**BUKRE CREEK HIGHWAY 50 CROSSING AND REALIGNMENT PROJECT – PHASE 1  
STATELINE, NEVADA**

Nevada Tahoe Conservation District  
400 Dorla Ct., PO Box 915  
Zephyr Cove, Nevada 89448  
(775) 586-1610

The following modifications are hereby made to the Bidding and Contract documents for the above referenced project:

**ADDENDUM NO. 1, Page 2 of 2**

REVEGETATION PLAN  
SCALE 1"=20'

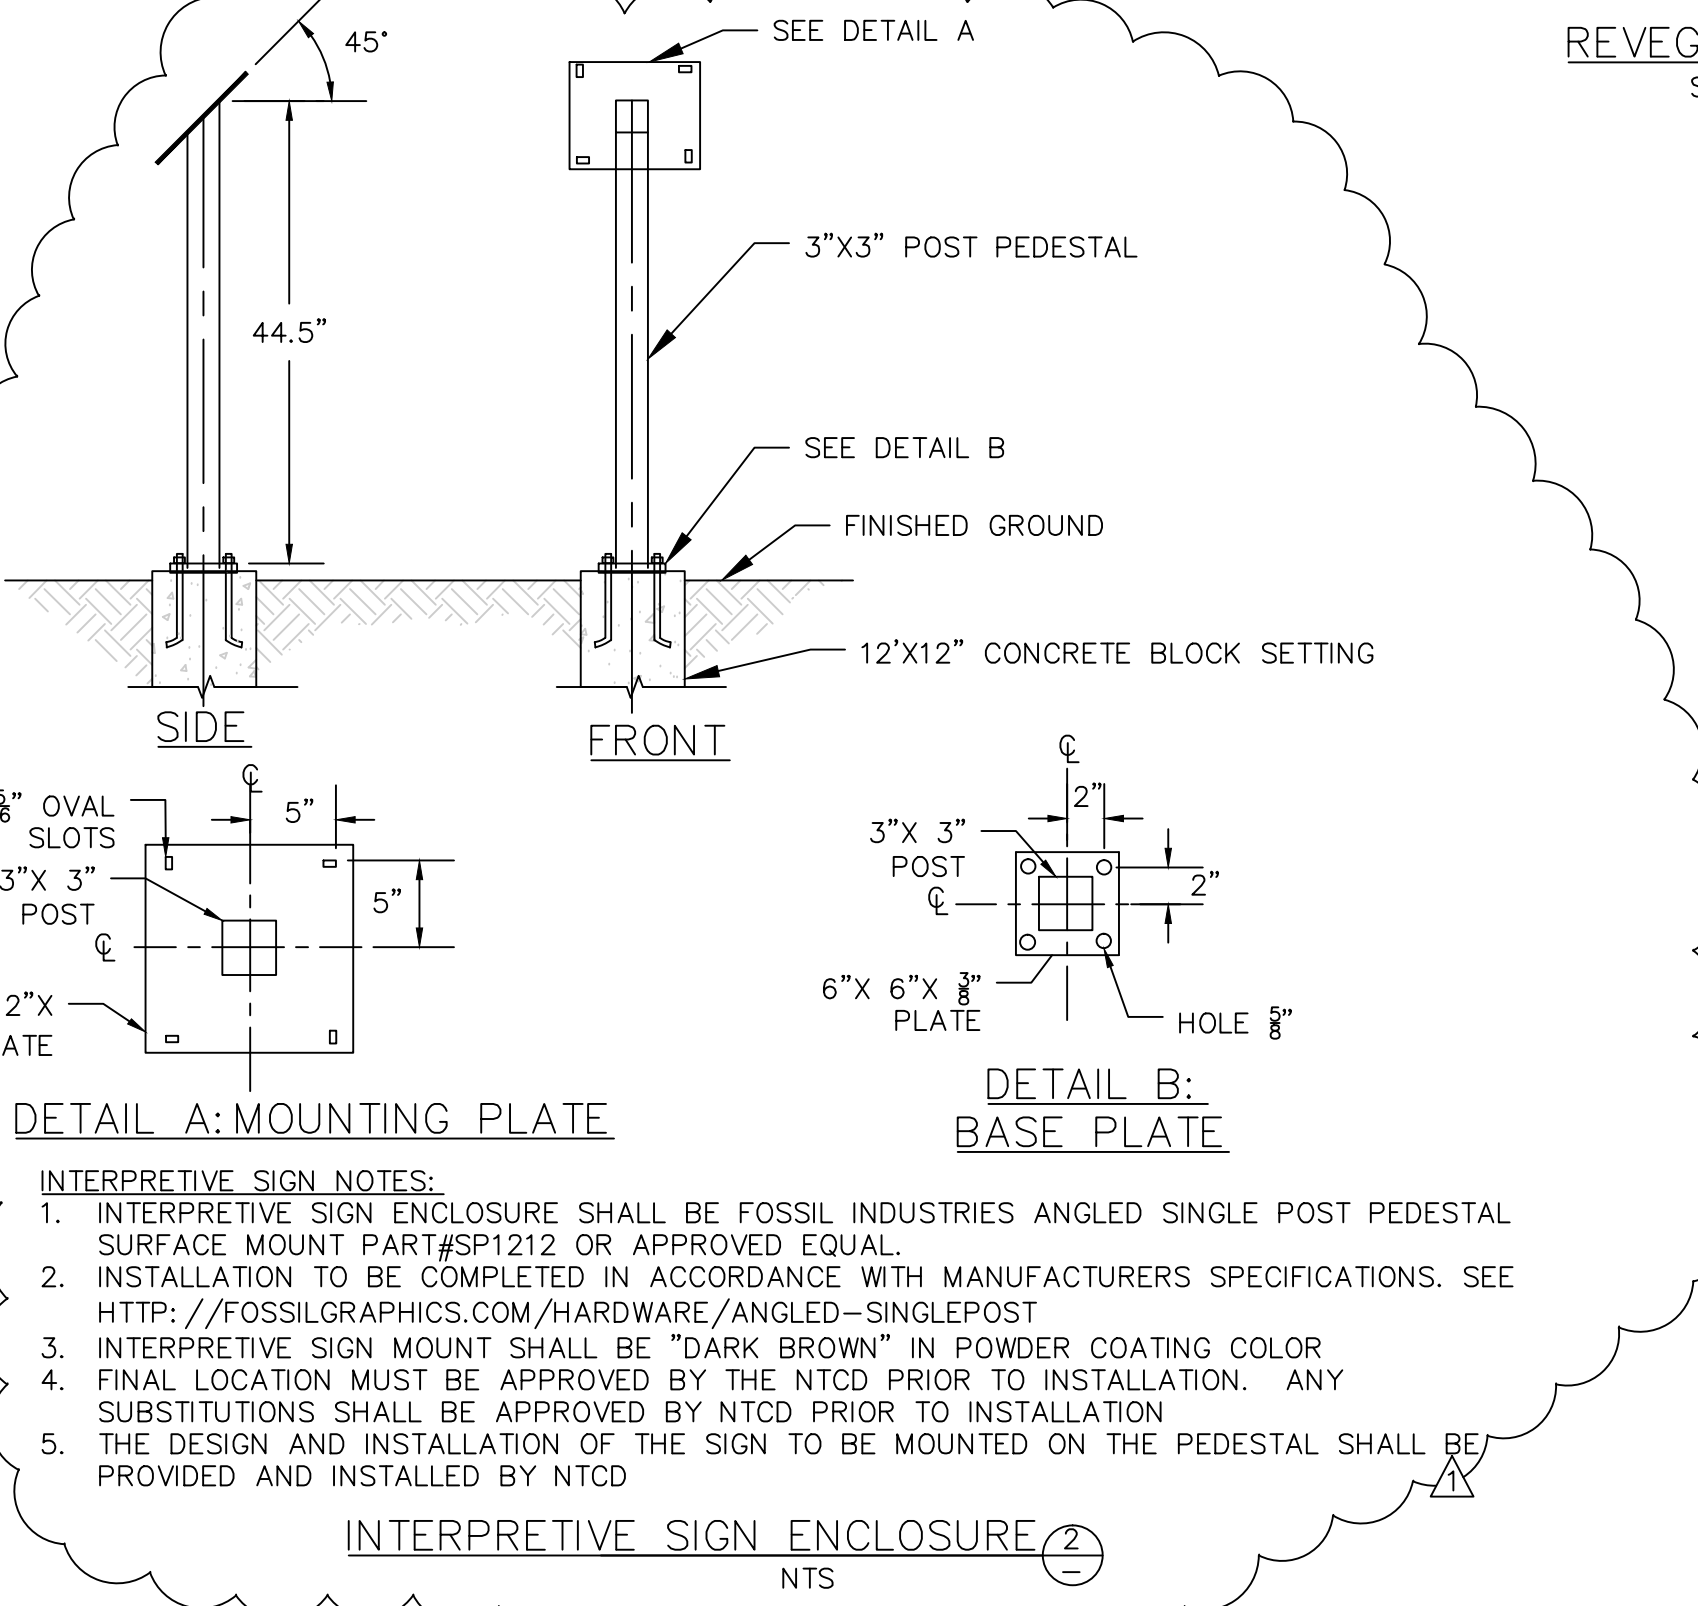
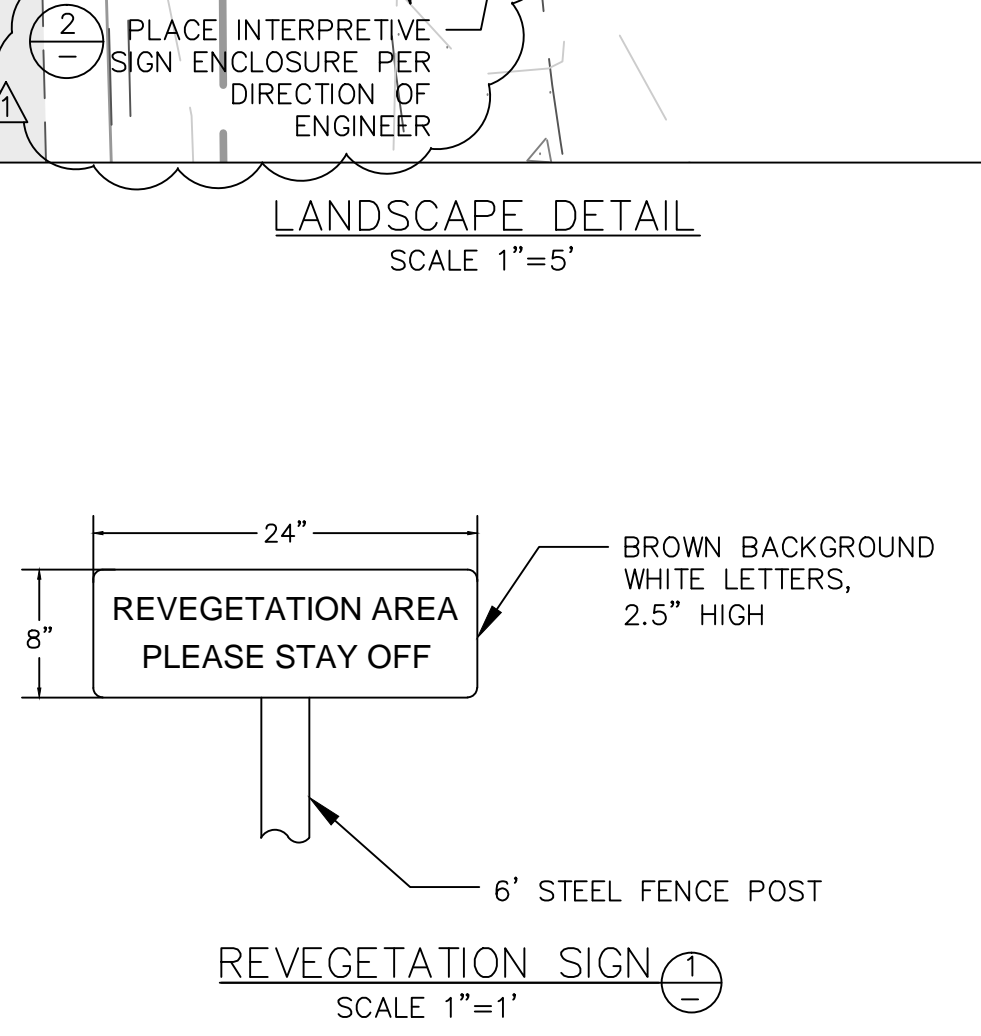
**ITEM 3:** On the Project Plans, Sheet R-1, shall be changed per the attached sheet to include a detail of the permanent interpretive sign post included in Bid Item No. 26, Highway Buffer Improvements, and note about irrigation water supply.

- IRRIGATION CONNECTION SHALL BE ESTABLISHED FROM IRRIGATION LINES WITHIN DOUGLAS COUNTY PARKING LOT STAGING AREA PARCEL APN 1318-23-401-047 OR OTHERWISE AS APPROVED BY KOD.

INTERPRETIVE SIGN ENCLOSURE (2)  
NTS

**WATER MAIN CROSSING** 1  
SCALE: N.T.S. D-6

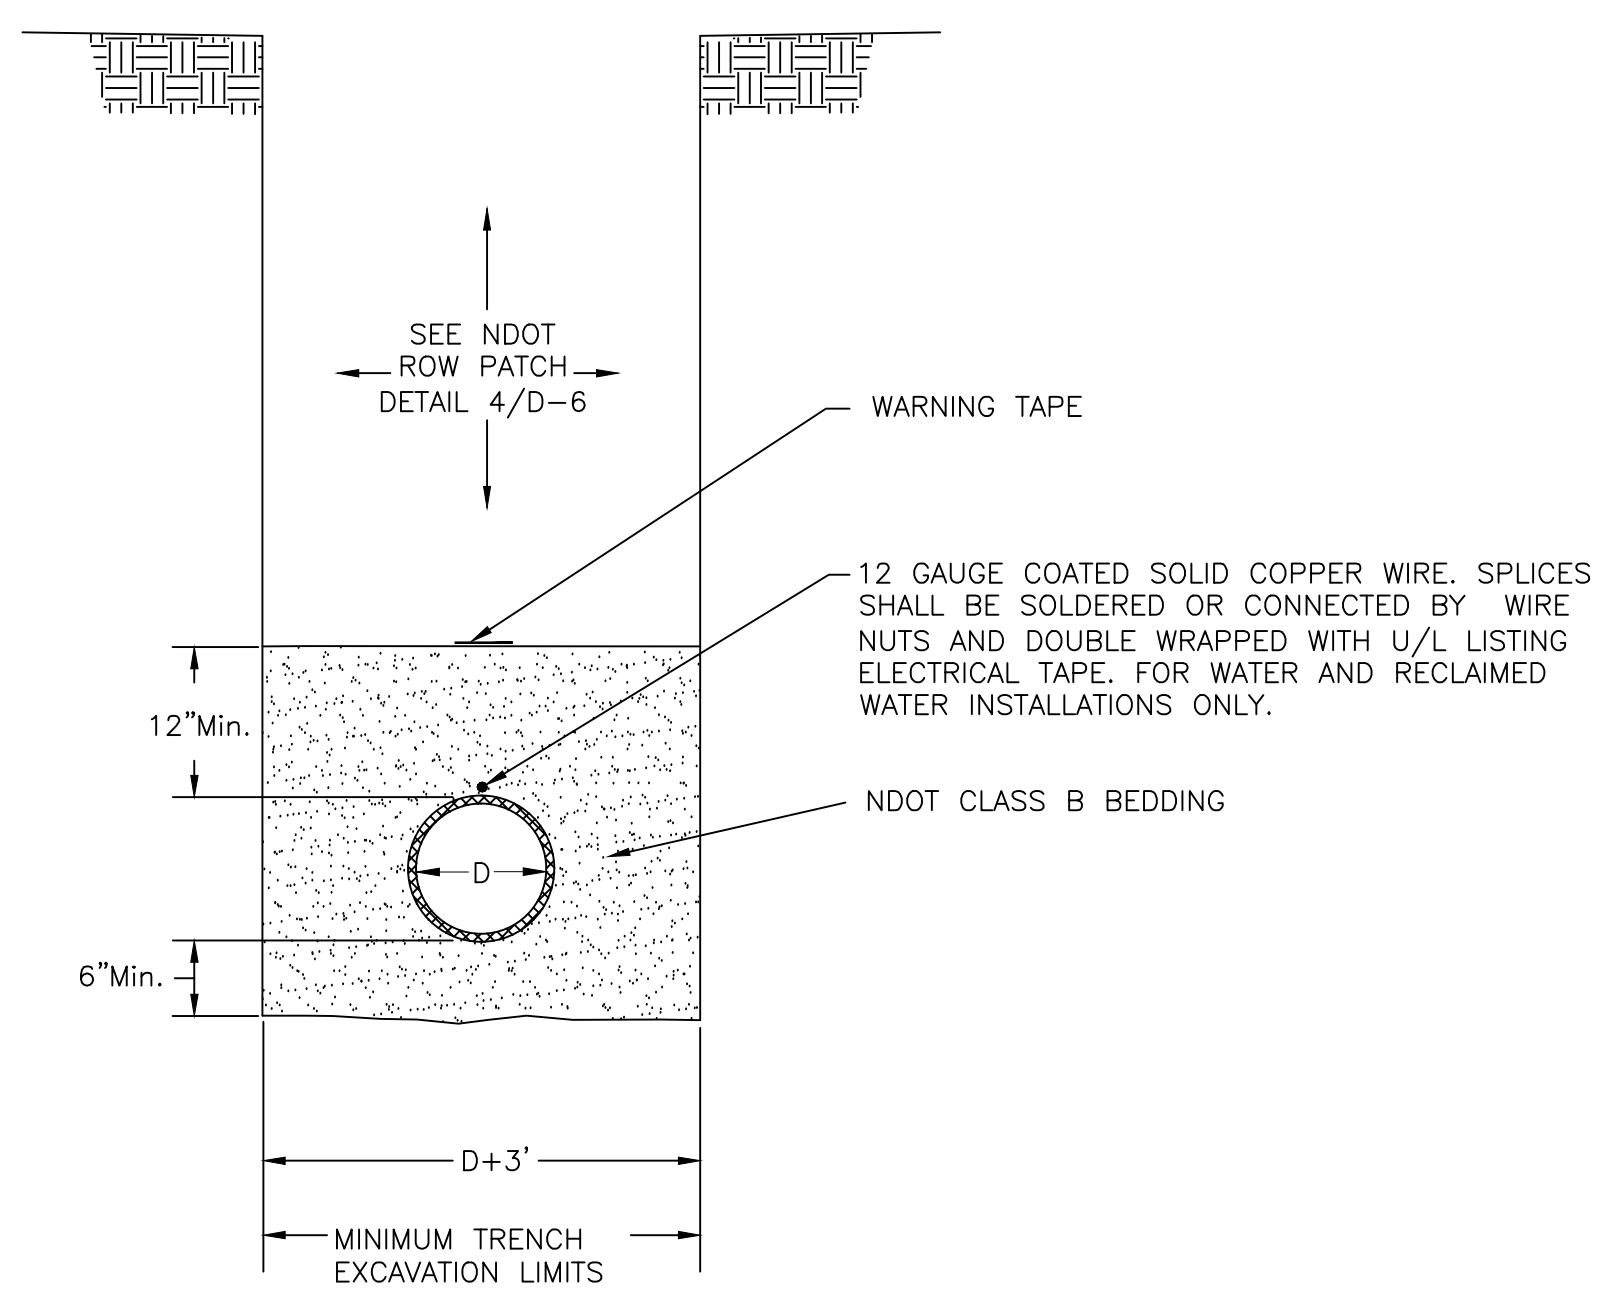
**ITEM 4:** On the Project Plans, Sheet D-6, Detail 1/D-6, shall be changed to reflect changes in pipe sleeve/casing requirements per attached sheet. Pipe casing references, notes, and call outs on sheet C-7 shall be modified to fifteen (15) feet.

- CROSSING NOTES:**
- FOR PURPOSES OF SEPARATION AND PROTECTION OF THE WATER SUPPLY, RECLAIMED WATER AND STORM DRAIN LINE SHALL BE CONSIDERED A SEWER LINE.
  - CUT ADJACENT PIPE SECTIONS AS REQUIRED TO CENTER FULL 20' WATERLINE PIPE LENGTH UNDER SEWER.
  - SLEEVE/CASING PIPE SHALL BE SIZED TO FIT 10" WATER MAIN, SPACERS, AND ALL OTHER APPURTENANCES. CASING PIPE SHALL BE NO LARGER THAN 1.5 TIMES THE O.D. OF THE WATER MAIN. CONTRACTOR SHALL BE RESPONSIBLE FOR SELECTING THE CORRECT DIAMETER OF CASING.
  - CONCRETE FOR THRUST BLOCKS SHALL NOT INTERFERE WITH THE REMOVAL OF BOLTED ASSEMBLIES.
  - ROUTING WATER LINE UNDER SEWER LINE REQUIRES APPROVAL BY THE WATER UTILITY.
  - CROSSING MUST COMPLY WITH NAC 445A.
  - CMAP SHALL BE INSTALLED WITH NO JOINTS OVER WATERLINE.

DESIGNED/DRAWN	MK/MK
CHECKED	MG
DATE	06/22/2016
SCALE	AS SHOWN
PROJECT	BCC
SHEET	<b>TC-1</b>
	1 OF 1

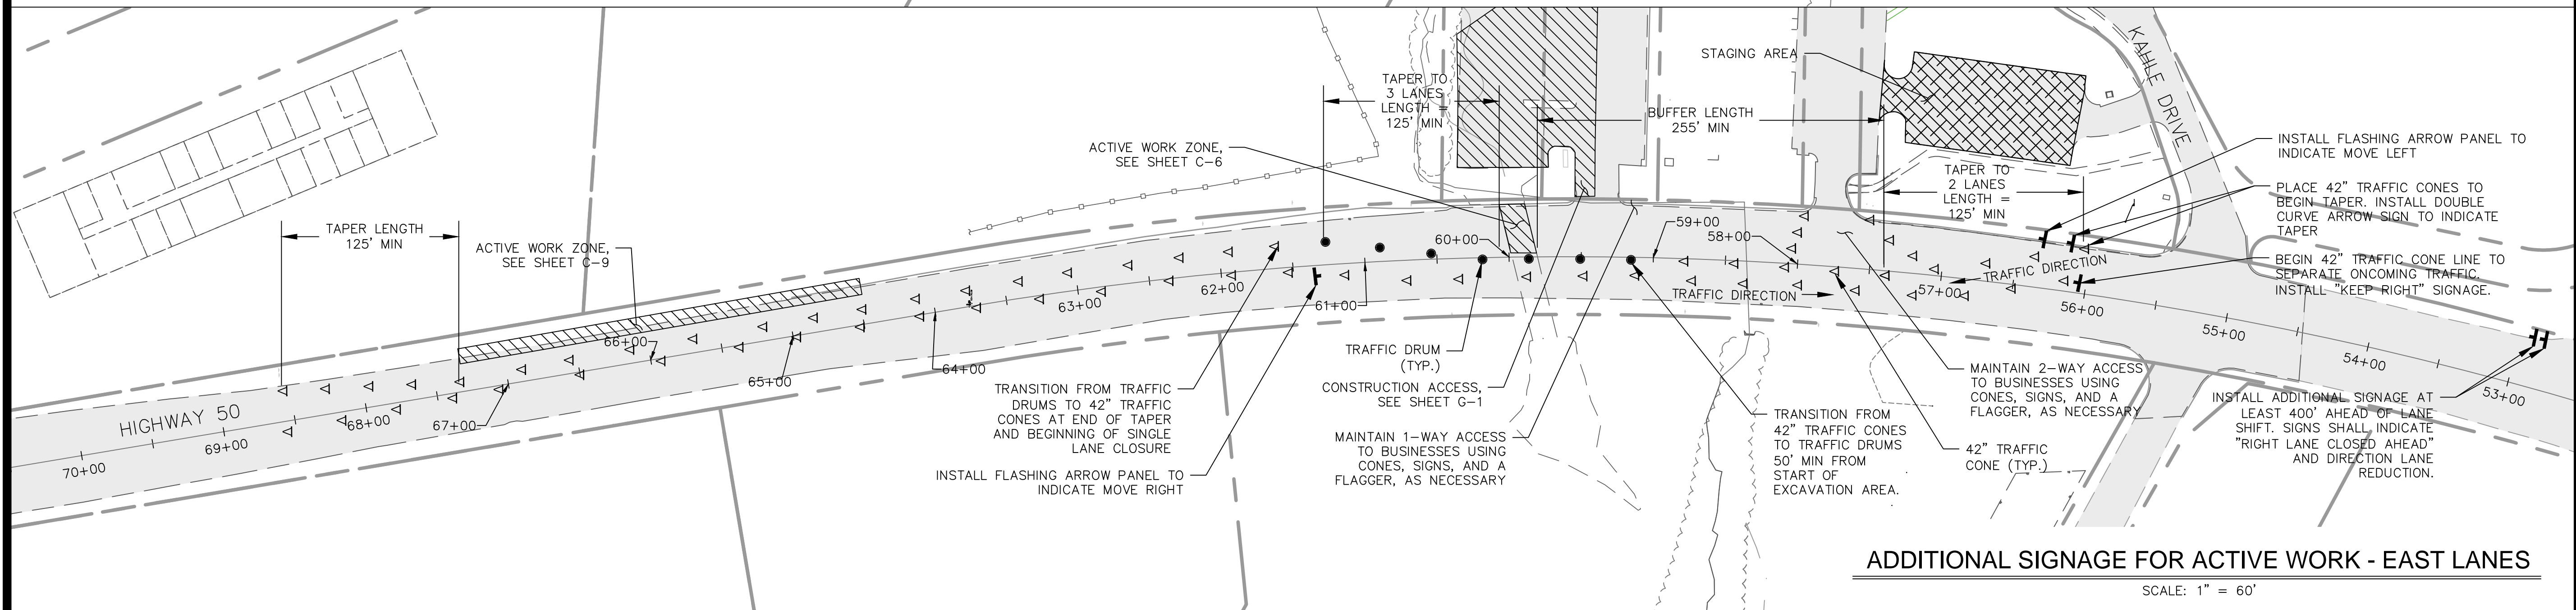
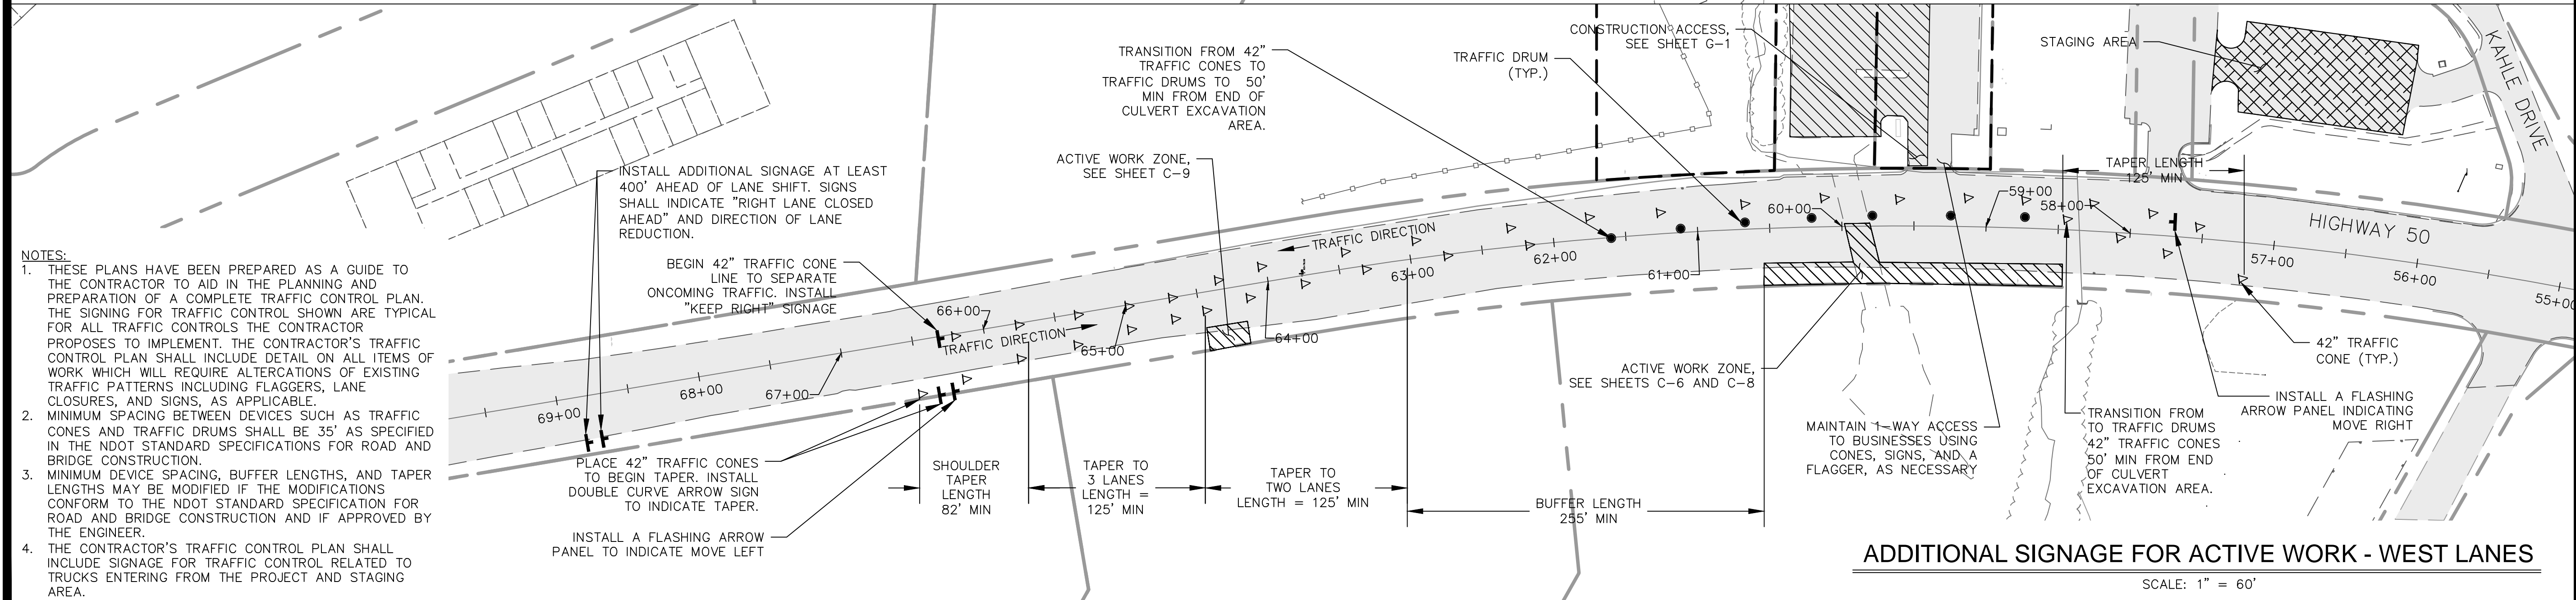
**ITEM 9:** Sheet TC-1, attached to this addendum, shall be incorporated into the project plan set as the base traffic control plan and the minimum required by NDOT.
